REGULAR MEETING OF THE PLAN COMMISSION OF THE VILLAGE OF WILLOWBROOK TO BE HELD ON WEDNESDAY, March 3, 2021 AT 7:00 P.M. AT THE WILLOWBROOK POLICE DEPARTMENT, DETECTIVE TRAINING ROOM, 7760 QUINCY STREET, WILLOWBROOK, ILLINOIS.

1. CALL TO ORDER
2. ROLL CALL
3. OMNIBUS VOTE AGENDA
 - A. Waive Reading of Minutes (APPROVE)
 - B. Minutes - February 3, 2021
4. PLAN COMMISSION CONSIDERATION: Continuation of Zoning Hearing Case 21-03: Consideration of a petition requesting approval of a special use permit for a planned unit development, including a financial institution with drive through, fast-food establishment with drive through, an automobile washing and cleaning facility, including certain relief, exceptions and variations from Title 9 and Title 10 of the Village Code; approval of a Preliminary Plat of Subdivision; and approval of a Preliminary Plat of PUD. The applicant for this petition is Alex Katz of G.W. Property Group LLC, 2211 N. Elston Avenue, Suite 304, Chicago IL 60614. The property owner is Viren-Gill Ltd., LLC, 735 Plainfield Road, Willowbrook IL 60527.

5. PLAN COMMISSION CONSIDERATION: Zoning Hearing Case 21-03: Consideration of a petition requesting approval of a speci

Exhibit 3 Fire Truck Exhibit

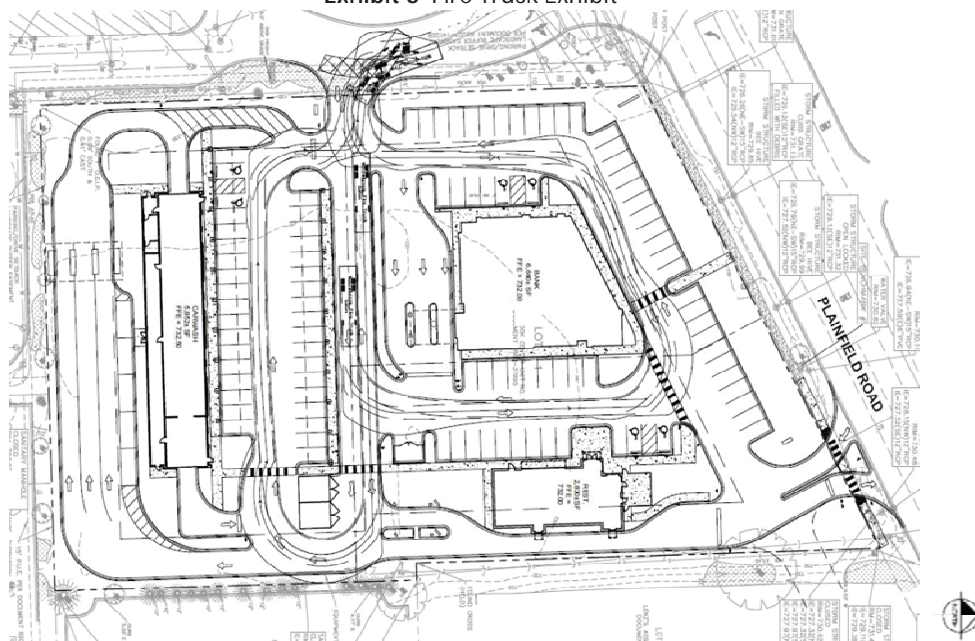
Staff requested that a revised site plan include all comments issued by Tri-State Fire Protection District regarding the width of drive aisles, location of trash enclosures, radii of curbs, and clear heights to Tri-State's satisfaction. In response, the Applicant provided a Fire Truck Exhibit, included under "Sheet EX" in **Attachment 3** of the staff report, and illustrated as **Exhibit 3** below. This exhibit and site plan have been reviewed and approved by Tri-State.

Exhibit 4 Ground Sign

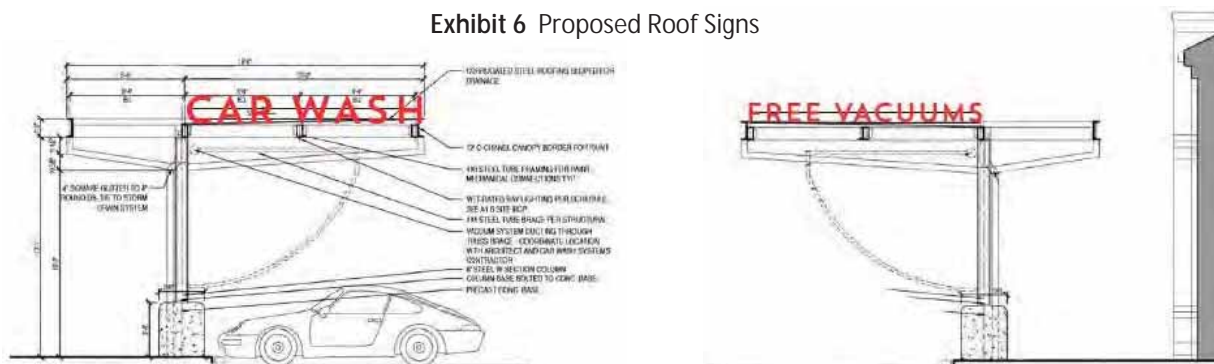
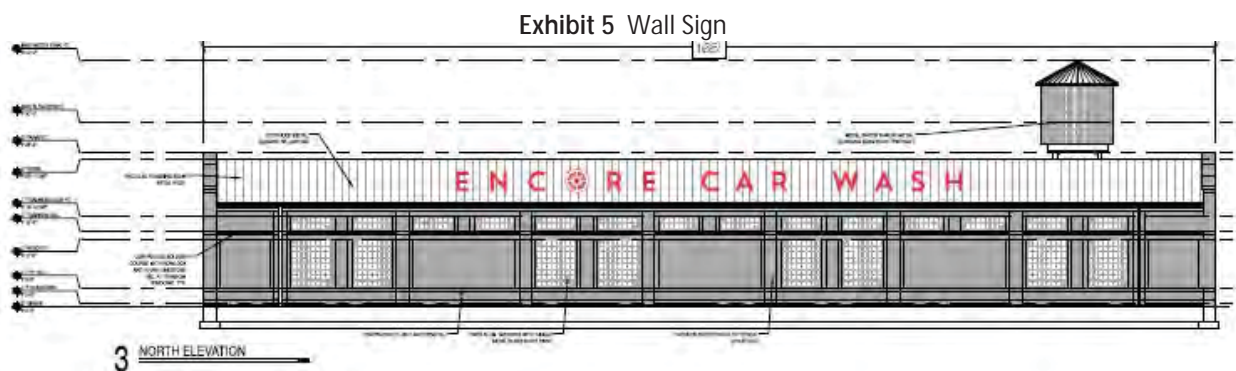
The proposed freestanding sign has been reduced to eight feet (8') in height.

Please note that the proposed freestanding sign also does not contain brick in keeping with the design of the principal structure. The following waivers from the Sign Ordinance are requested for Lot 1:

Exhibit 15 Stacking Exhibit

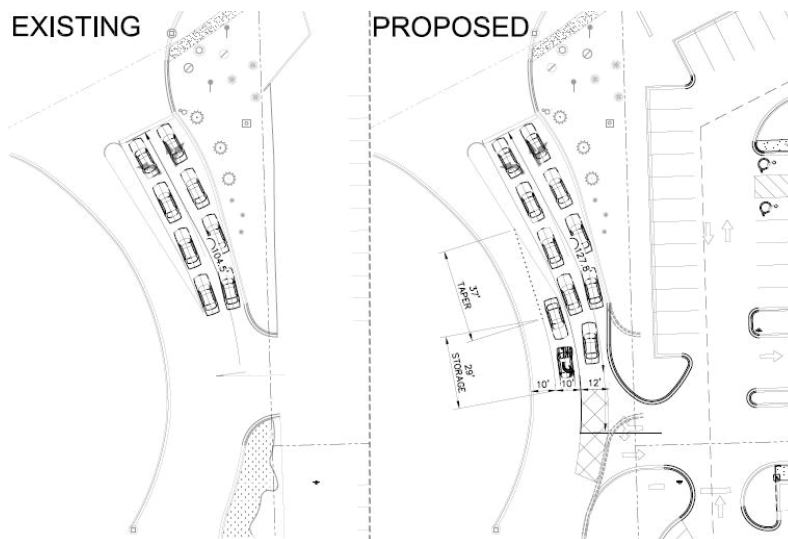
The Plan Commission also requested more detail regarding the shared access drive between the subject property and the Town Center. The Applicant has provided a stacking exhibit included as **Attachment 7** that illustrates the existing conditions of the shared access driveway between the subject property and the Town Center, with a driveway storage that accommodates approximately four (4) cars in the north-bound lane and suggests approximately four (4) cars in the south bound lane. The stacking exhibit also illustrates the proposed conditions, in a side-by-side comparison, of the relocated driveway (approximately 20 feet to the south) and the incorporation of a dedicated left-turn lane into the subject property. The proposed conditions show the relocated driveway increases the driveway storage to five (5) cars with approximately two (2) cars within the left-turn lane.

Exhibit 16 Plainfield Road Access (Right-In/Right-Out)

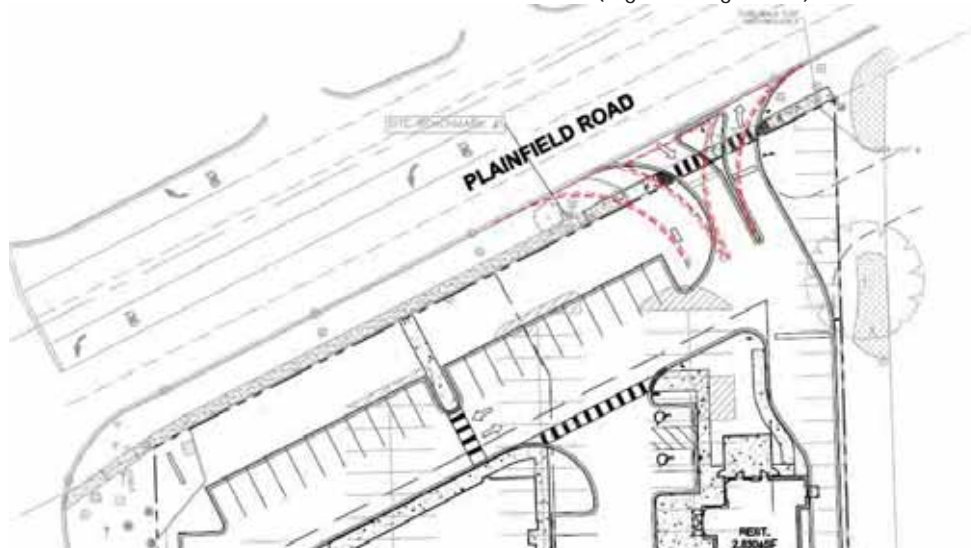
The Plan Commission also asked the Applicant about the possibility of extending the east curb of the Plainfield Road “pork chop” to discourage vehicles from making a left-turn onto Plainfield Road. The Applicant provided the following exhibit, included as **Attachment 8** of the staff report.

In order for the “flare” of the curb radius to avoid any intrusion into the neighbor’s right-of-way area to the east, the driveway access has been shifted to the west. The exhibit depicts a larger radius for the pork chop at the Plainfield Road access. While ultimately the access will be reviewed and approved by DUDOT, the Applicant provides the following reasons for maintaining the originally proposed geometry and not the alternative for the following reasons:

ORIGINAL ISSUE:
12/15/2020
KHA PROJECT NO:
168726009
SHEET NUMBER:
L2.0

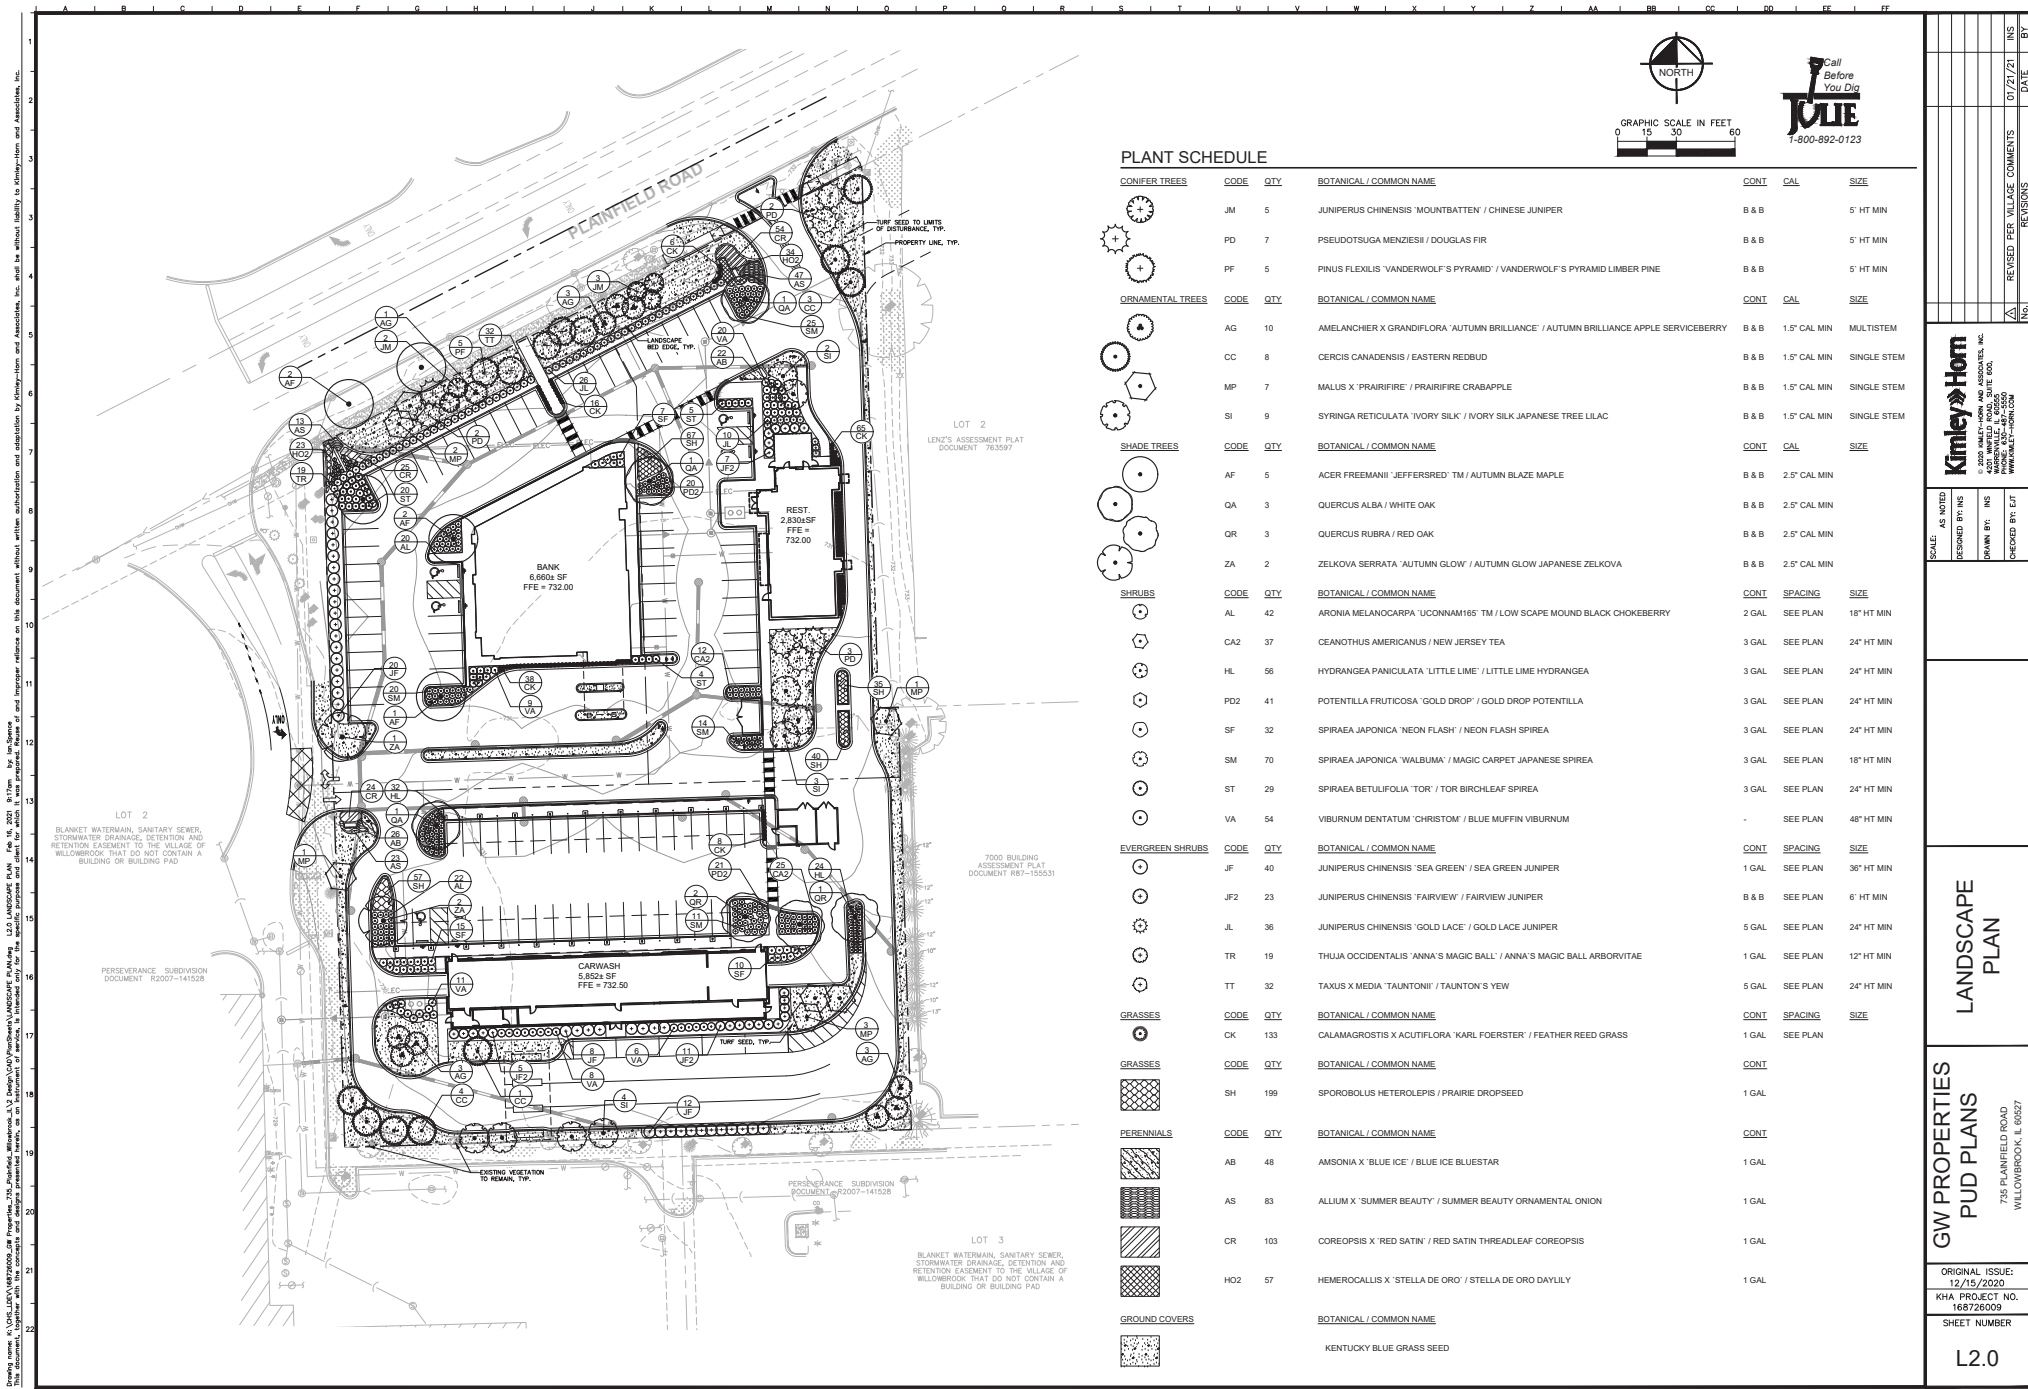
12. Sheet L2.0 Landscape Plan labels the 53 "AB" perennials (near the ground sign of the shared drive with Town Center) when these should be 53 "HO2" perennials to correspond to the total number of HO2 perennials (110). The total number of "AB" perennials is correct at 22.

15. Sheet L2.0 Landscape Plan labels 2 "ZA" shade trees on Lot 1 (near the last vacuum station) when this should be 1 "ZA" shade tree to correspond to the total number of ZA shade trees (2) in the Plant Legend.

E5

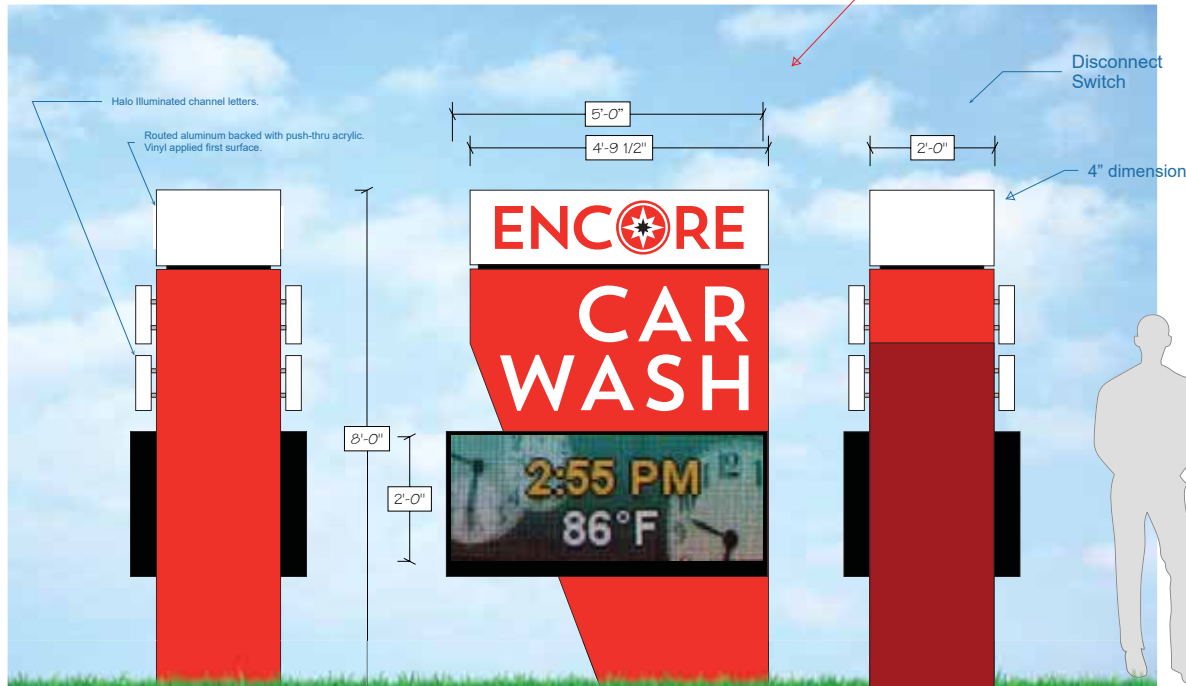
20. Staff calculates Sign E.5 as slightly higher than what is listed on Sheet 7B. Staff calculates each face of the sign to be 35.92 SF for a total of 71.84 SF. **Please adjust the total proposed SSA accordingly.**
21. The three signs E.6 should also count both faces towards the SSA requirement of 4 SF. Each sign is 12 SF. Please adjust on those sheets. **A waiver for SSA is required.**
